METROPOLITAN GOVERNMENT OF NASHVILLE AND DAVIDSON COUNTY

STAFF RECOMMENDATION
1815 Forrest Avenue
February 20, 2013

Application: New construction—addition
District: Lockeland Springs-East End Neighborhood Conservation Zoning Overlay
Council District: 06
Map and Parcel Number: 08310027100
Applicant: Gina Emmanuel
Project Lead: Melissa Baldock, melissa.baldock@nashville.gov

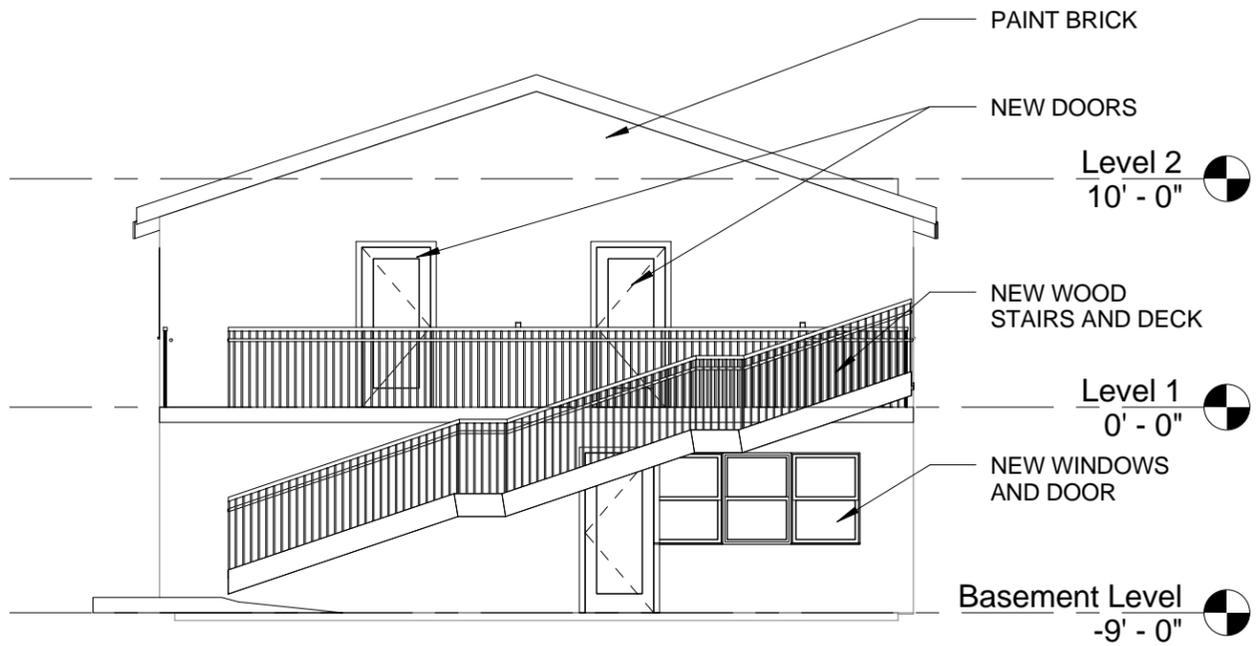
Roof Form/Addition: The existing structure has a front-gabled roof with a slope of approximately 3.5/12. The front of the gable currently projects beyond the wall of the house, and there is an overhang of approximately three feet, three inches (3'3") at its deepest. The applicant is proposing to extend the roof out to create a larger overhang for the entryway. The extended overhang would project eight feet (8') beyond the wall of the structure at its furthest point. The overhang will not attach to any posts, but will

cantilever out over the entryway. The height of the existing structure will not be altered. Staff finds that extending the roof over the front entryway meets the design guidelines because the existing structure is non-contributing and the alteration of the roof will not negatively impact the surrounding historic character of the district. Staff finds that the roof alteration meets Section II.B.5. and II.B.10 of the design guidelines.

② North
1/8" = 1'-0"

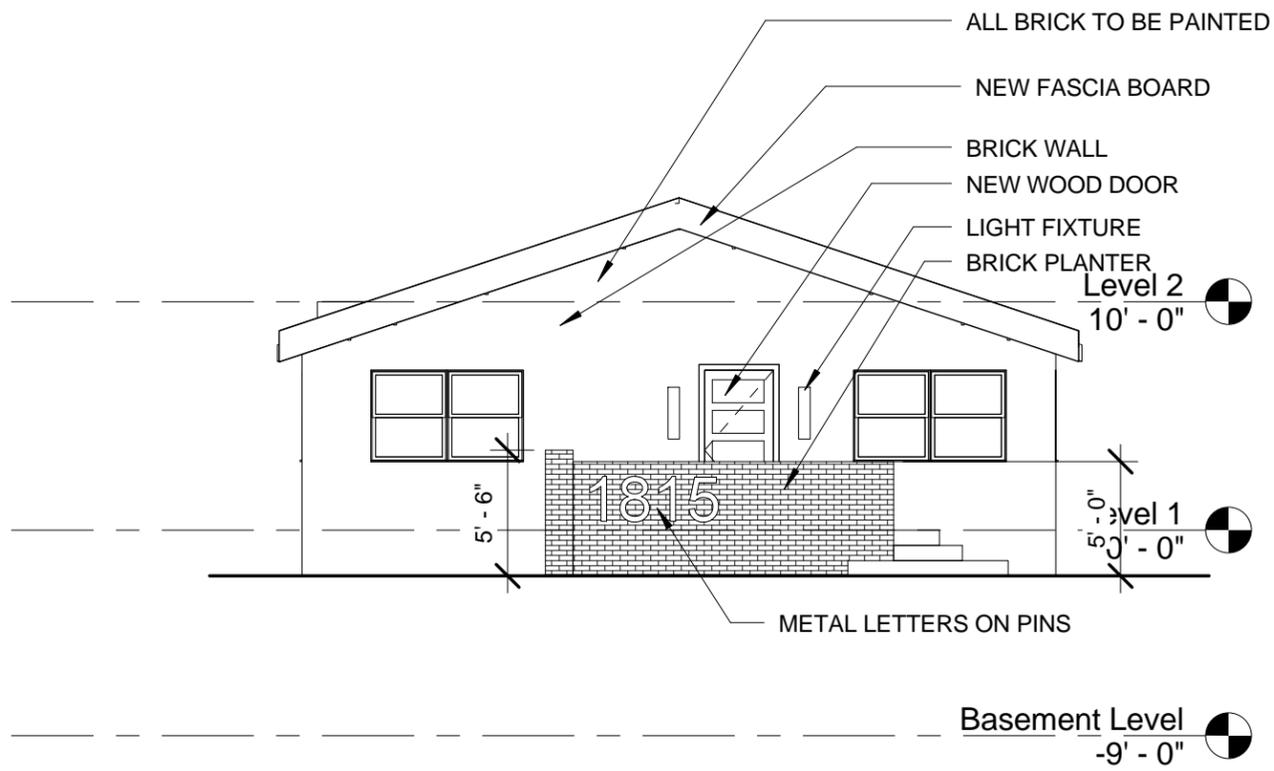
Proportion and Rhythm of Openings. The project involves altering the door and window pattern on the structure. On the front façade, there are currently two central doorways. The application involves removing the left doorway and installing a new wooden door in the right doorway. On the right elevation, the applicant will be installing two, paired window openings towards the front of the structure, and will be removing two window openings at the back of the structure. On the rear façade, two new doorways will be created, leading to the new uncovered deck. Staff finds that the alterations to the window and door openings are appropriate since the structure is non-contributing and the alterations will not negatively impact the historic character of the district. Staff does ask to review the window and door materials and specifications prior to purchase and installation. Staff finds that the changes to the window and door pattern meet Sections II.B.7. and II.B.10. of the design guidelines.

① South
1/8" = 1'-0"

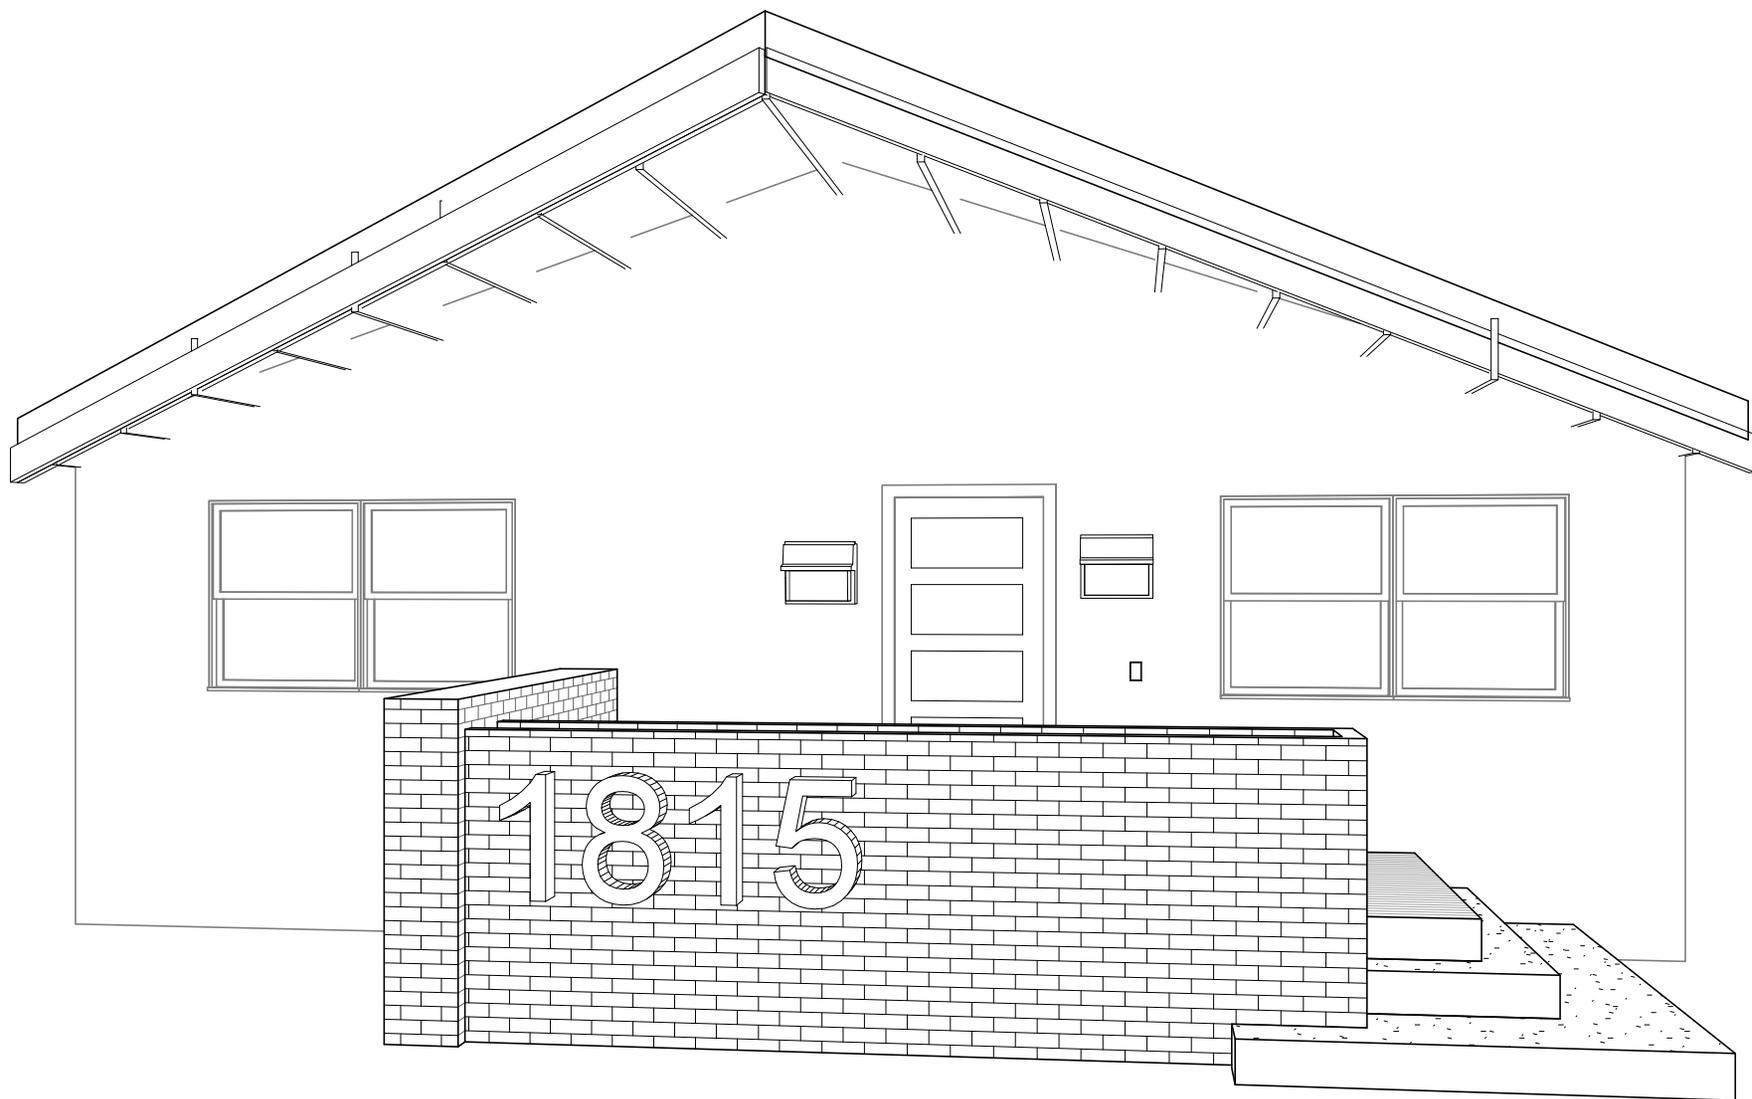
Entryway Wall. The applicant is proposing to construct a brick wall framing the entryway. It will be open on the right side. The wall will be five feet (5') tall at the front, and five feet, six inches tall (5'6") on the left side. The wall will be one foot, two inches thick on the left side. The front portion of the wall will be two feet (2') thick and will serve as a planter. Staff finds the addition of the entryway wall to meet the design guidelines because the building is a non-contributing structure and the wall will not negatively impact the historic character of the surrounding neighborhood. Staff finds that it meets Sections II.B.9. and II.B.10. of the design guidelines.
